City of Hastings

Planning Commission Memorandum

To: Planning Commission
From: John Hinzman, Community Development Director
Date: June 11, 2012
Item: Preliminary & Final Plat – Riverwood 11th Addition

RIVERWOOD 11TH ADDITION

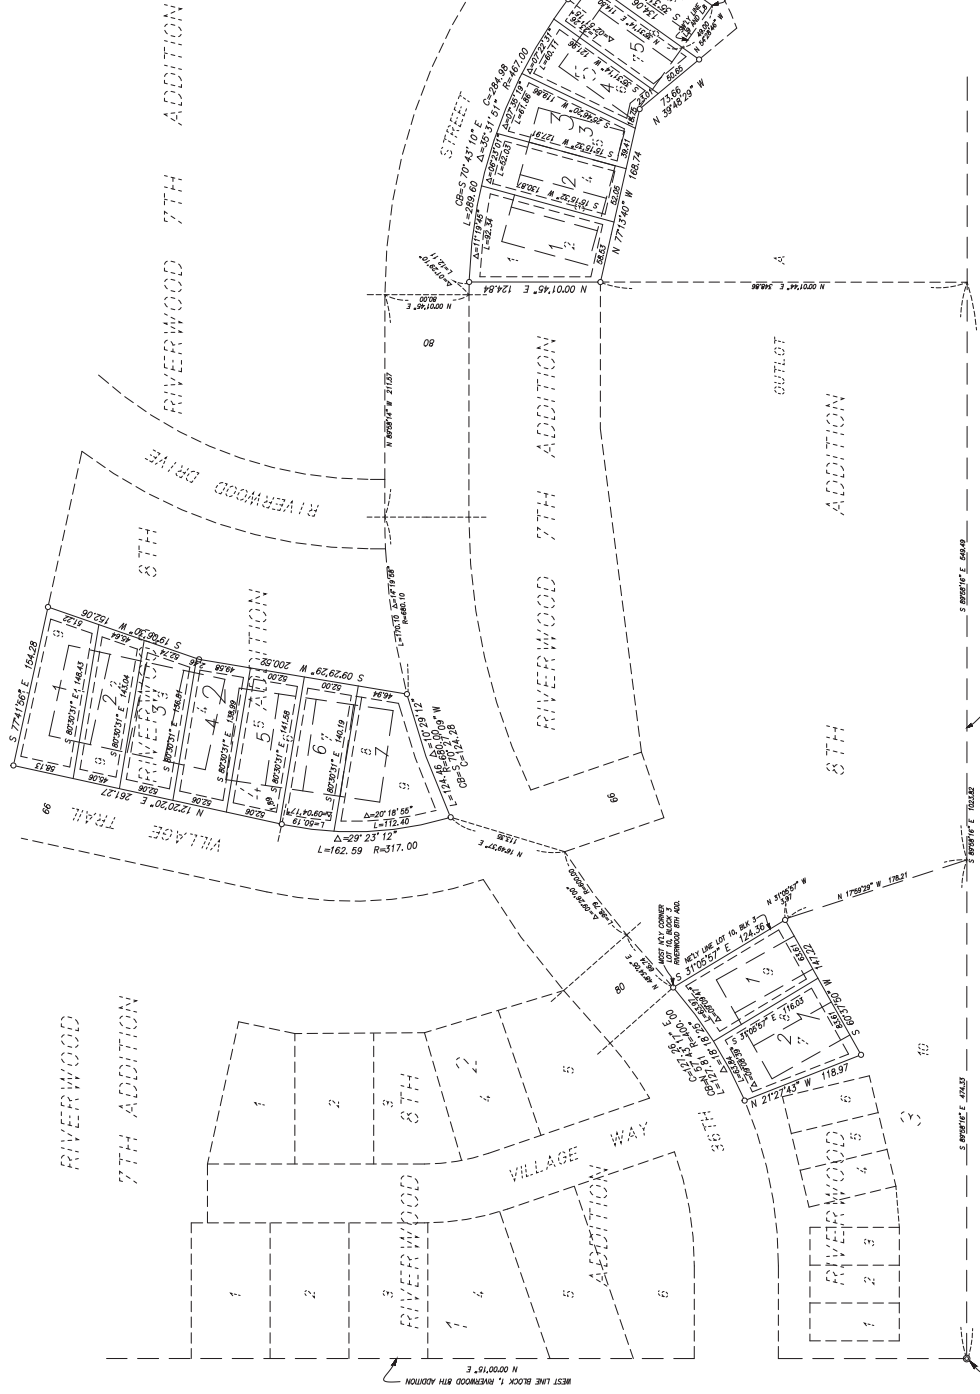
Proposed lots meet minimum size requirements. The proposed lot arrangement involves subdivision of common ownership lots established in Riverwood 8th Addition. Since this is no longer a townhome subdivision, the applicant may want to consider eliminating the common lots in their entirety and allocate portions to abutting private owners. In particular the elimination of the remnant lot below should be strongly considered:

1. All homes shall be constructed with a driveway turnaround to allow vehicles the opportunity to avoid backing into a collector roadway.

1. Submittal of a Grading, Drainage, and Erosion Control Plan for Riverwood 11th Addition for approval by the Public Works Department. The Plan must reflect the change from a townhome to a single family residential development.

1. Unneeded utilities service lines must be capped or tied into adjoining lines to the satisfaction of the City Engineer.
2. An agreement indicating property owner responsibility for unused/abandoned/interconnected utility services lines, and agreeing to pay additional future expenses in the event of failure of the same unused/abandoned/interconnected utility service lines must be filed at the county with the associated property. All recording expenses for these agreements shall be paid by the developer.

1. All disturbed areas shall be stabilized with rooting vegetative cover to minimize erosion.
2. Disturbed areas shall adhere to the City's property maintenance ordinance.

3. Vacation of the underlying drainage and utility easements prior to recording of the Final Plat.
4. All lots shall be constructed with a driveway turnaround to allow vehicles the opportunity to avoid backing into a collector roadway.

5. All lots shall be subject to the 35' front yard setback provision for homes fronting collector roadways.
6. Submittal of a Grading, Drainage, and Erosion Control Plan for Riverwood 11th Addition for approval by the Public Works Department. The Plan must reflect the change from a townhome to a single family residential development.

7. Unneeded utilities service lines must be capped or tied into adjoining lines to the satisfaction of the City Engineer.
8. An agreement indicating property owner responsibility for unused/abandoned/interconnected utility services lines, and agreeing to pay additional future expenses in the event of failure of the same unused/abandoned/interconnected utility service lines must be filed at the county with the associated property. All recording expenses for these agreements shall be paid by the developer.
